Sterling Creations Ltd. (9620)

Beron, Earpur Union, Ashulia, Dhaka

02.July.2014

Identified Priority 1 Concerns

2nd Priority 2 Concern

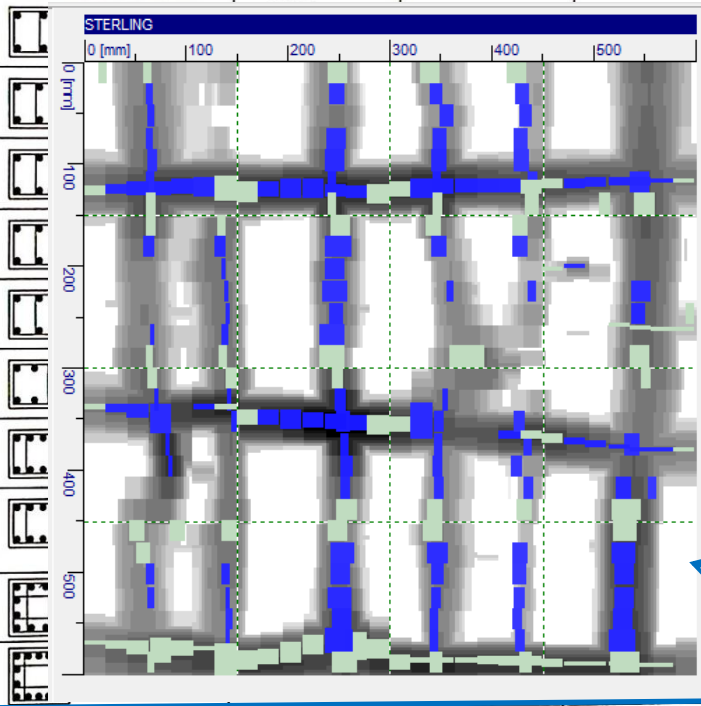
High stresses to internal columns, factor of safety between 1.5 & 1.86 based on current loading.

We were advised that the design loadings for the floors were 80psf (4.0kPa). If all floors are loaded to 80psf the columns would be further overstressed.

5	Priority 2 - High stresses to internal columns, factor of safety between 1.5 & 1.86.	Carry out any recommendations highlighted in the Engineering Assessment.	6-months
6	Priority 2 - Structural drawings do not match column reinforcement discovered during Ferro-scanning.	Establish if drawings are original design or post dated as built drawings. Survey all columns as part of the Detailed Engineering Assessment to ascertain the existing design strength of the columns.	6-weeks
7	Priority 2 - Structural drawings do not match column reinforcement discovered during Ferro-scanning.	If drawings are as built remove any information that can not be verified by basic survey methods.	6-months

Structural drawings do not match rebar discovered during Ferroscanning.

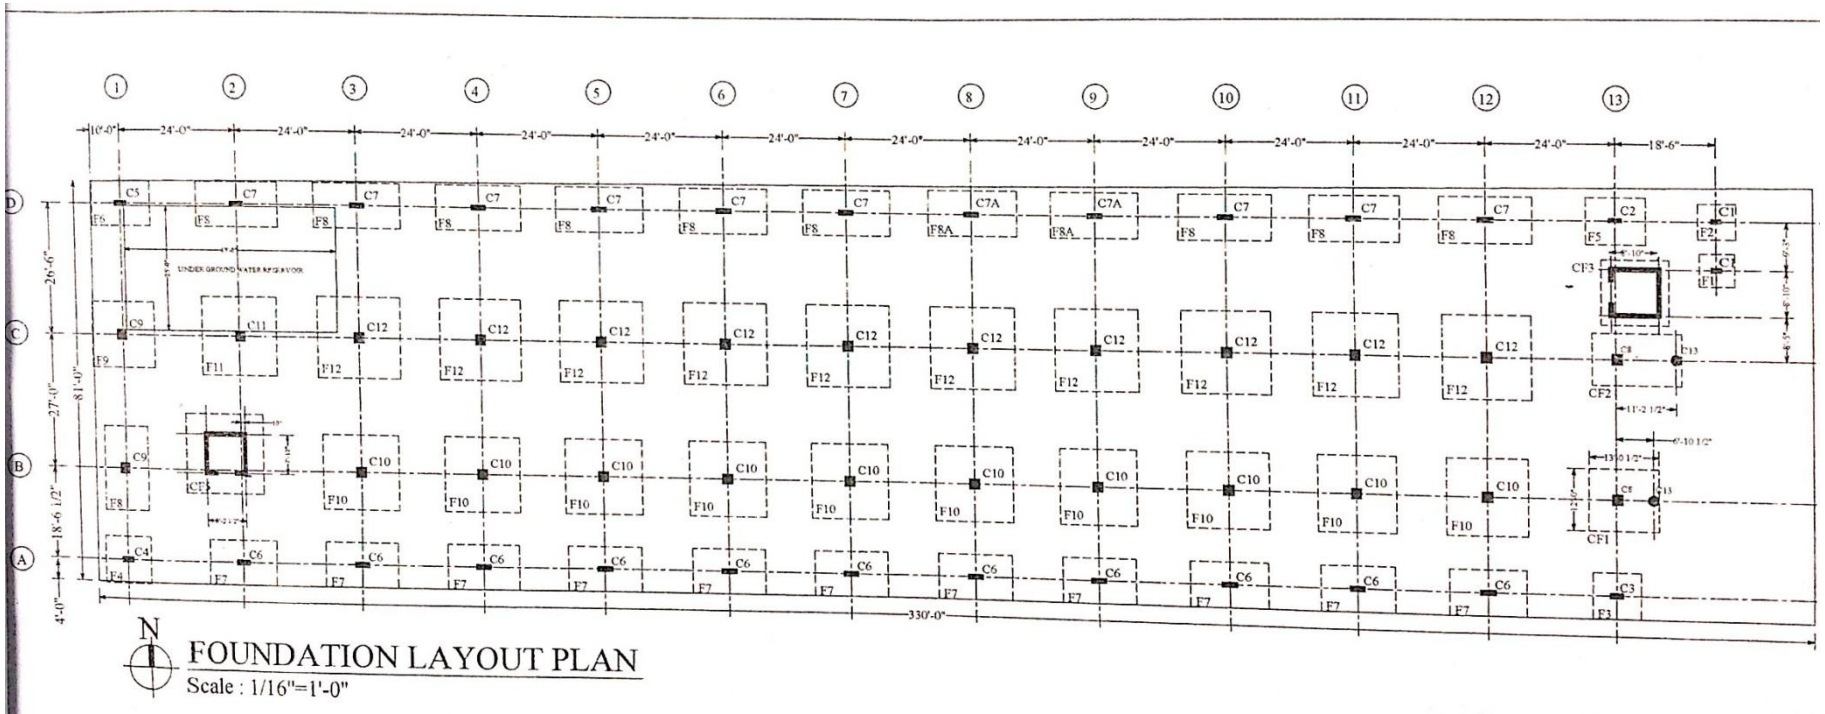
Based on the construction drawings provided we would have expected to see 24 bars in the **C12** column scanned.

While the drawings are dated 2005 it is possible that they may be as built drawings since construction started in 2004.

From the Ferroscon 6 bars were discovered on one face and 5 bars on the adjacent face. Therefore a total of 18 bars in the column.

The discovered results are a closer match with **C10**, which is the same size with fewer bars.
